Water Quality Technical Memorandum Addendum

New Pueblo Freeway Phase 1

CDOT Project No. IM 0251-156

Purpose of Addendum

Exhibit 1 - Phase I
Northern Avenue

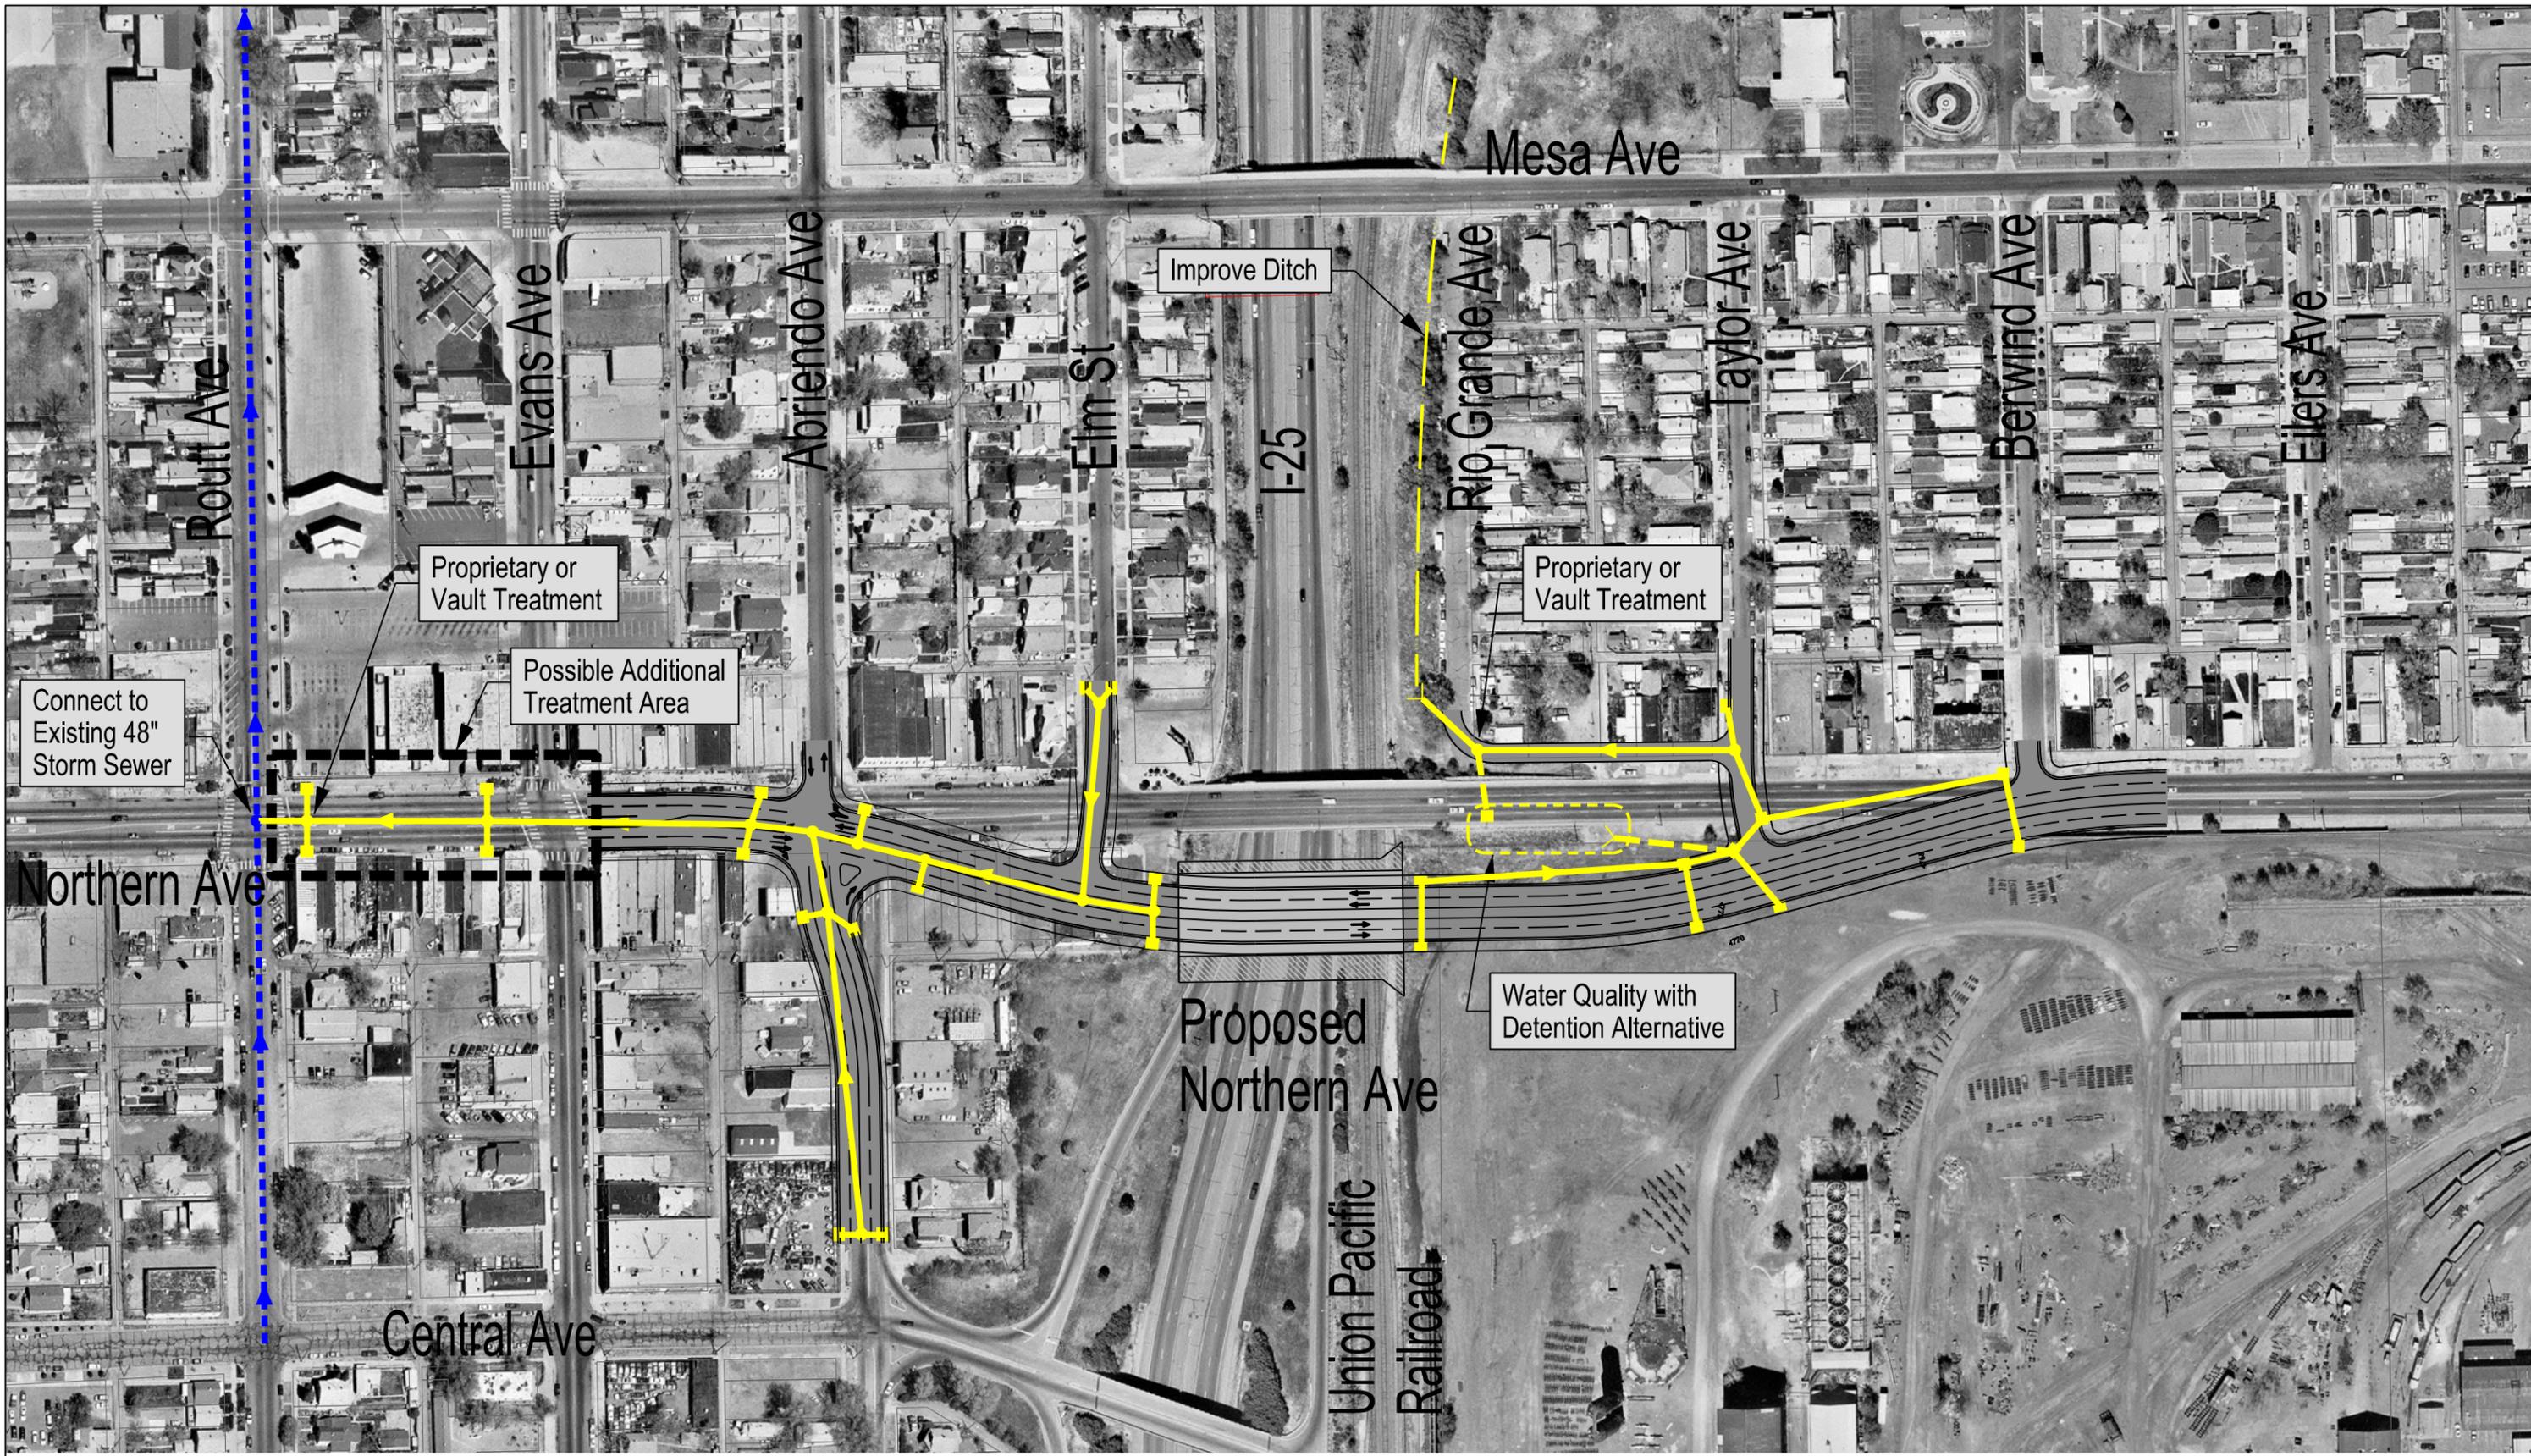
The Northern Avenue Bridge project is within the Pond 4A and 4B onsite basin areas. The conceptual design consists of the pond locations and approximately 4,000 feet of storm drain system discharging north into the Arkansas River. Neither of the ultimate ponds 4A and 4B would be constructed in Phase I because Interstate 25 (I-25) will not be relocated until the ultimate project is constructed. In the Phase I interim condition, storm drains would be constructed within Northern Avenue on each side of the proposed bridge over I-25.

The west-side storm drain would convey runoff to an existing storm drain running north under Routt Avenue. Water quality would be provided by proposed proprietary facilities located immediately upstream of the existing Routt Avenue drain. The proprietary system could also treat runoff from the section of Northern Avenue located just west of the project limits between Routt and Evans Avenues. Credit for this treatment of non-project runoff could be applied to compensate for other project areas that may prove impractical to treat.

The proposed storm drain on Northern Avenue east of I-25 would discharge to an existing swale to the east of the Union Pacific Railroad (UPRR) near I-25. This swale along the east side of the UPRR would need to be deepened to accept runoff originating from Northern Avenue east of Taylor Avenue. Discharge to the swale would require an agreement with the railroad. Because a wider Northern Avenue would create more runoff into the swale, an agreement with the railroad may require construction of a detention pond. Should detention be required, a pond would be constructed within the existing Northern Avenue alignment between Rio Grande and Taylor Avenues.

A proprietary or vault system would still be needed to treat runoff from the proposed frontage road connecting Rio Grande Avenue to Taylor Avenue. The frontage road storm drain would release into the ditch along the UPRR. Again, use of the ditch would require an agreement with the railroad. The interim elements could be incorporated into the ultimate outfall system.

Exhibit 2 - Phase I
Ilex Avenue

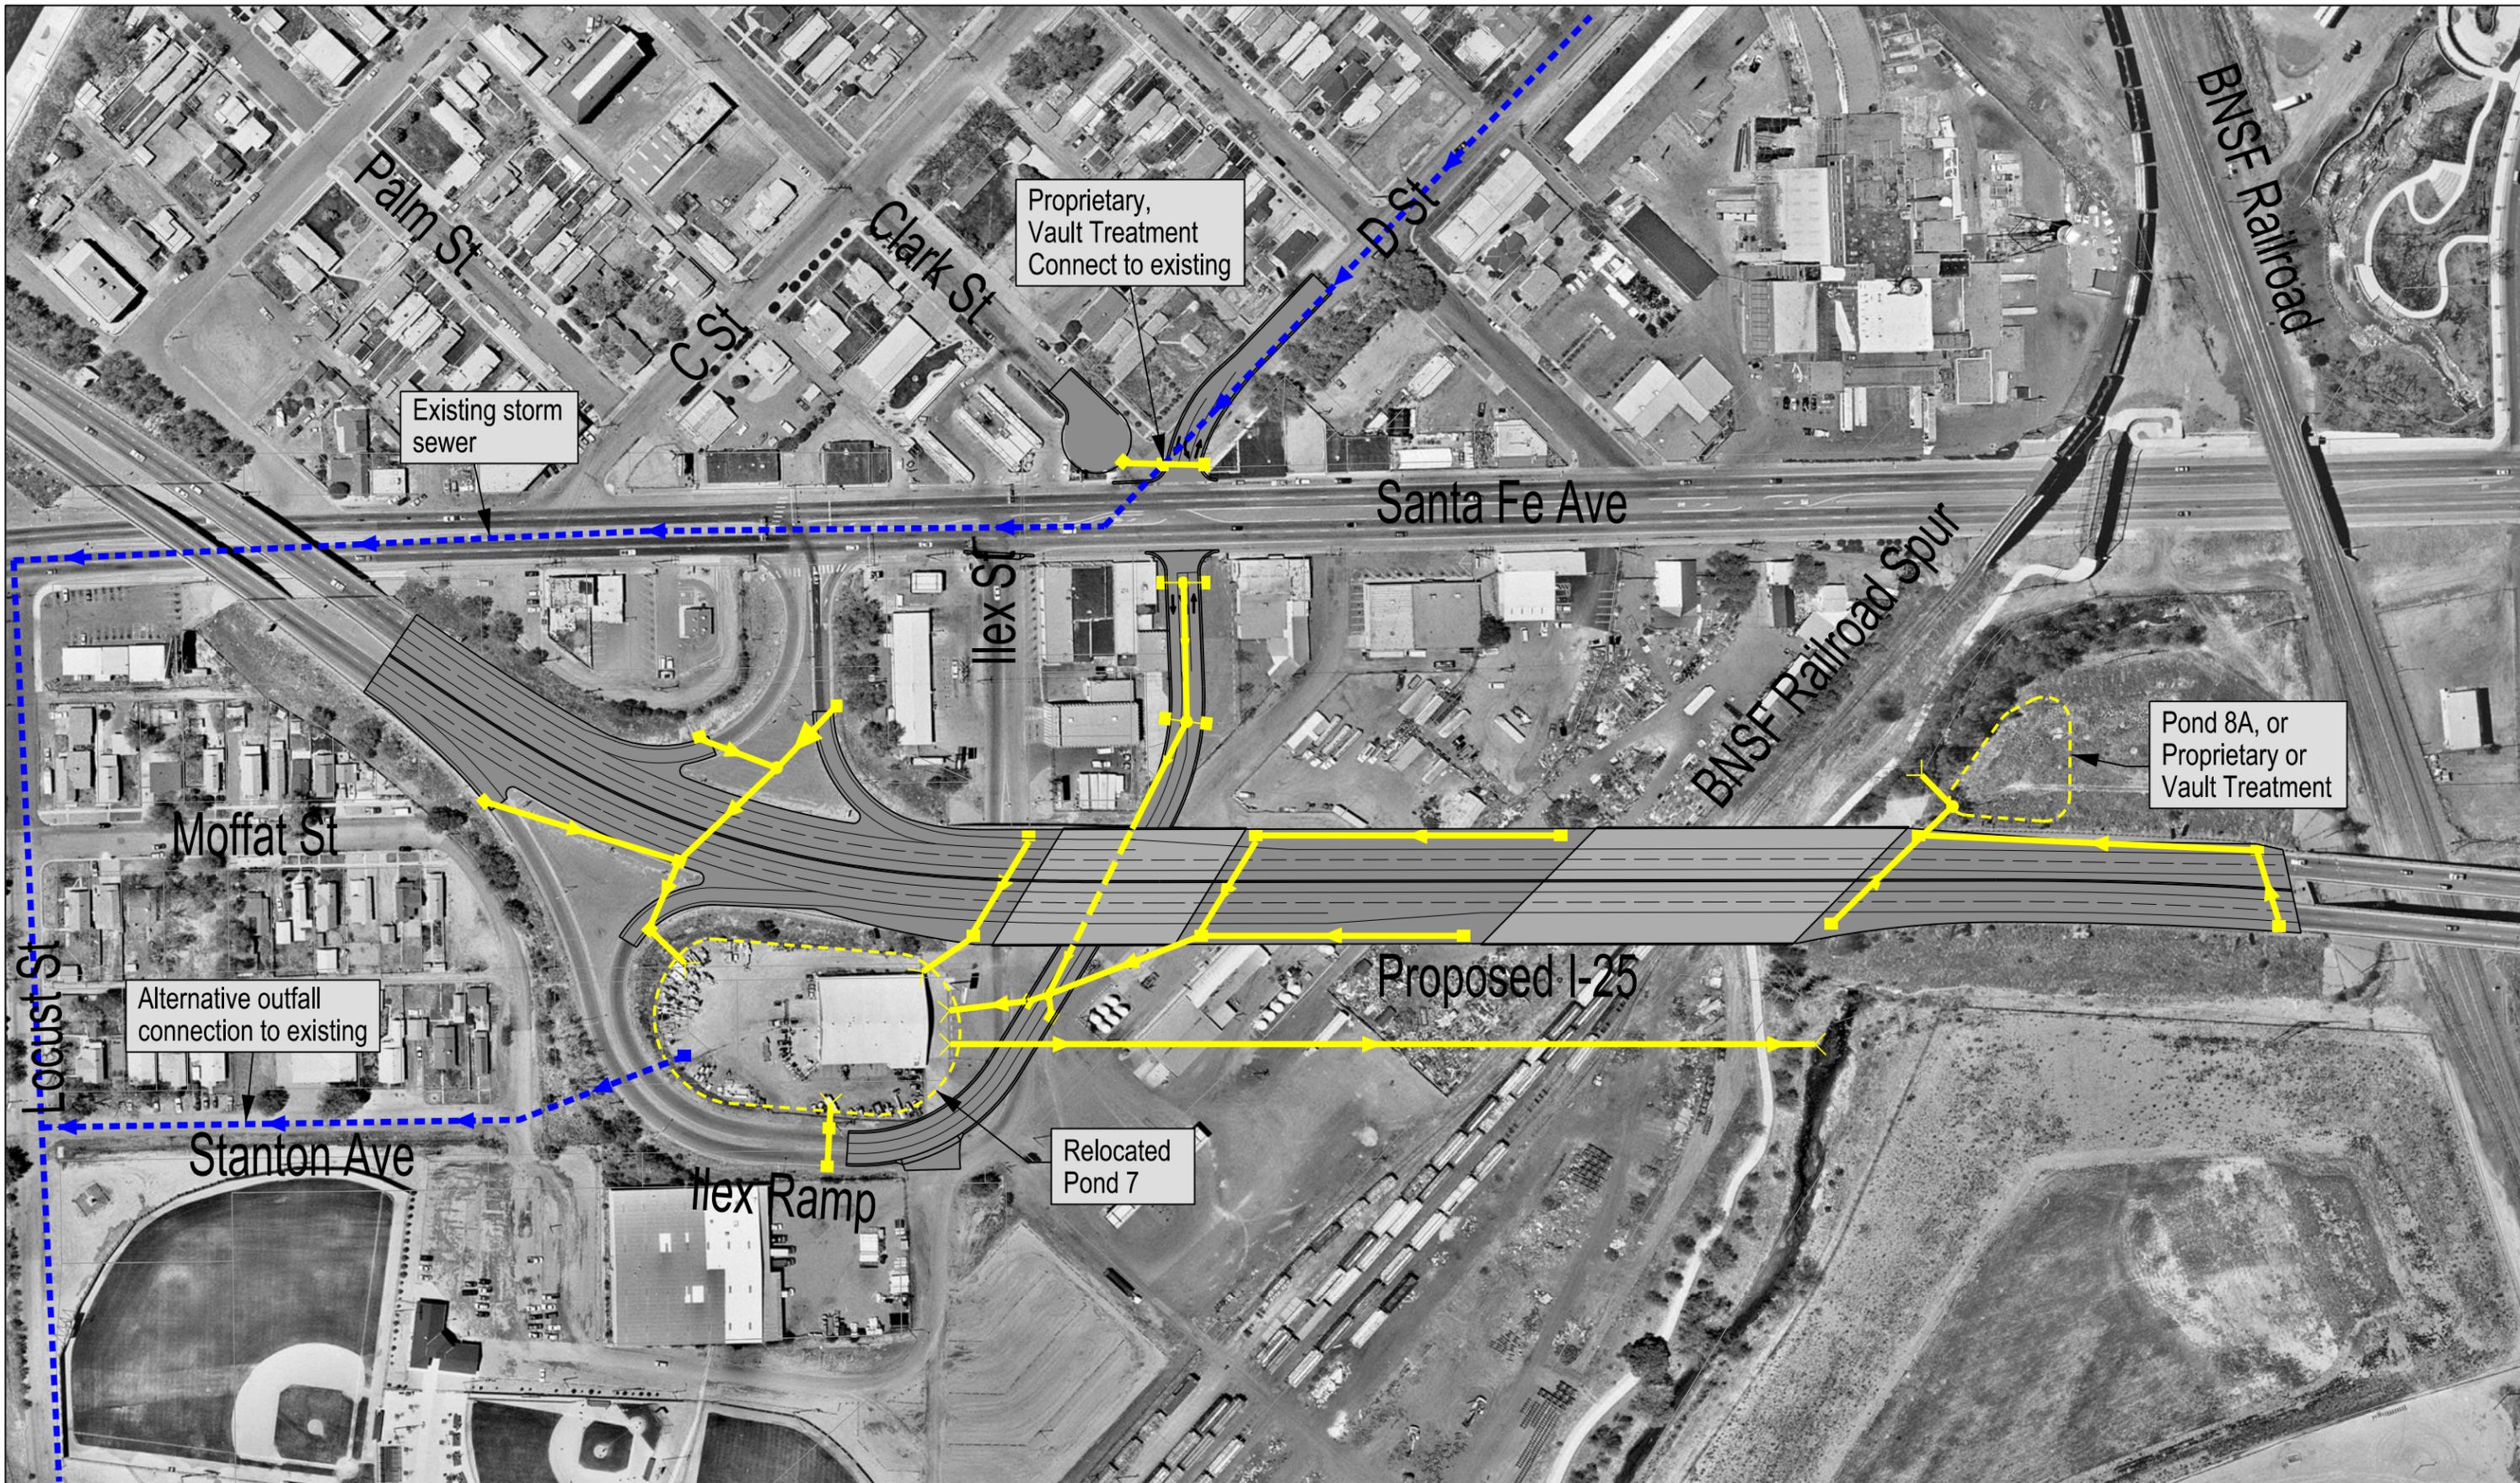
The Ilex Avenue Bridge project is within the Pond 7 and 8 onsite basin areas. The original location for Pond 7 is not feasible with the modified alignment. Existing I-25 will remain in place on the original Pond 7 site through the Phase I construction period. Pond 7 is proposed to be relocated to the infield area of the Ilex Ramp.

Pond 8A would be constructed north of the Burlington Northern Santa Fe (BNSF) railroad spur between I-25 and Santa Fe Avenue. If the site should prove too steep to place a pond, a proprietary or vault system could be used. This system would discharge into the Arkansas

Pond 8, which was to be located east of I-25 between the BNSF railroad spur and the Arkansas River tributary, is not likely to be feasible because the required pipe below the railroad spur would be too low to outlet into the Arkansas River tributary. The relocated Pond 7 would discharge to the tributary north of the BNSF railroad spur via approximately 1,000 feet of storm drain. Alternatively, the relocated Pond 7 could discharge into a new storm drain that would be constructed within Stanton Avenue. This storm drain would convey flow south and connect to an existing storm sewer in Locust Street.

Drainage from D Street and Clark Street west of Santa Fe Avenue would be treated using a proprietary system prior to discharging into the existing Santa Fe Avenue storm drain.
